Well Name: BIG BUCKS FED COM	Well Location: T21S / R32E / SEC 12 / NENE / 32.500491 / -103.621126	County or Parish/State: LEA / NM
Well Number: 502H	Type of Well: OIL WELL	Allottee or Tribe Name:
Lease Number: NMNM0553706	Unit or CA Name:	Unit or CA Number:
US Well Number: 3002547435	Well Status: Approved Application for Permit to Drill	Operator: ASCENT ENERGY LLC

Notice of Intent

Procedure Description: Ascent Energy respectfully requests approval to revise the proposed BOP from a 5M BOP to a 2M BOP for the Big Bucks Fed Com 502H from beneath the base of the 20" surface shoe to setting the 1st Intermediate casing string only (13 3/8"). This revision is requested to accommodate the increase in the previously mentioned 1st Intermediate casing diameter of that string. Please see attached document for BOP schematic and sundry request specifics.

PECOS DISTRICT DRILLING CONDITIONS OF APPROVAL

2M ANNULAR BOPE & DIAGRAM

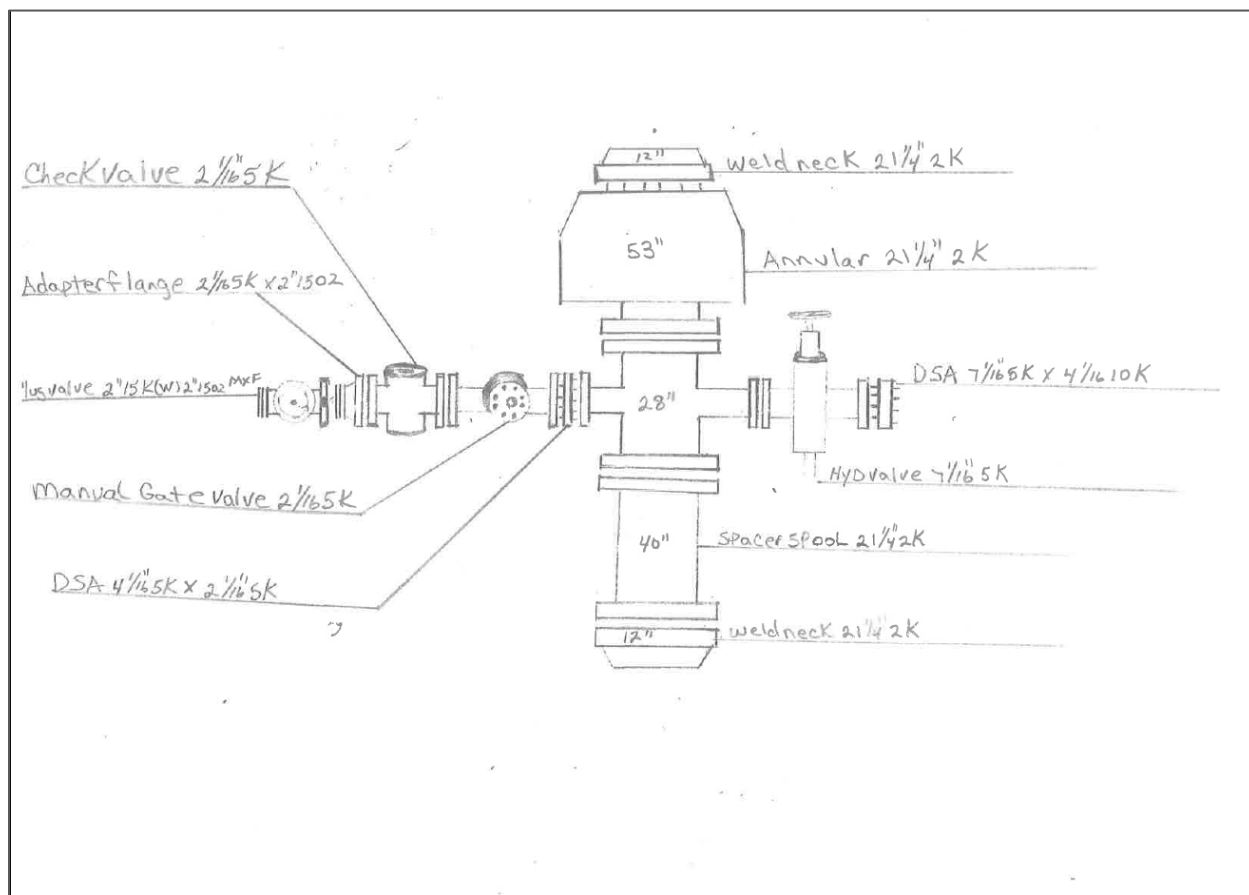
Ascent Energy respectfully requests approval to revise the proposed BOP for the Big Bucks Fed Com 502H from beneath the base of the 20" surface shoe to setting the 1st Intermediate casing string only (13 3/8"). This revision is requested to accommodate the increase in the previously mentioned 1st Intermediate casing diameter of that string.

From the Base of the 20" Surface pipe, the well will be equipped with a 2M Annular system. Before drilling out the 20" surface pipe, the 2M system will be tested to 250psi low and 1000psi high by an 3^d party service company. The 2M BOPE and related equipment will meet or exceed the requirements of a 2M psi system as set forth in On Shore Order No. 2 while drilling below the 20" surface shoe and to TD of Intermediate #1 (13-3/8" Casing). Once the Intermediate #1 13-3/8" Casing is cemented the 20" 2M BOPE and 21-1/4" wellhead will be removed and a 13-5/8" Multi-bowl wellhead and previously permitted 13-5/8" 5M BOPE will be installed. From the base of the Intermediate #1 13-3/8" casing string through running of the 5-1/2" production string the 5M BOPE will be equipped.

The previously permitted 5M choke will be utilized in conjunction with the 2M Annular System.

2. Operator has proposed a multi-bowl wellhead assembly. This assembly will only be tested when installed on the surface casing. Minimum working pressure of the blowout preventer (BOP) and related equipment (BOPE) required for drilling below the surface casing shoe shall be **2000 (2M) psi**.

3. Operator has proposed a multi-bowl wellhead assembly. This assembly will only be tested when installed on the surface casing. Minimum working pressure of the blowout preventer (BOP) and related equipment (BOPE) required for drilling below the intermediate 1 and 2 casing shoe shall be **5000 (5M) psi**.
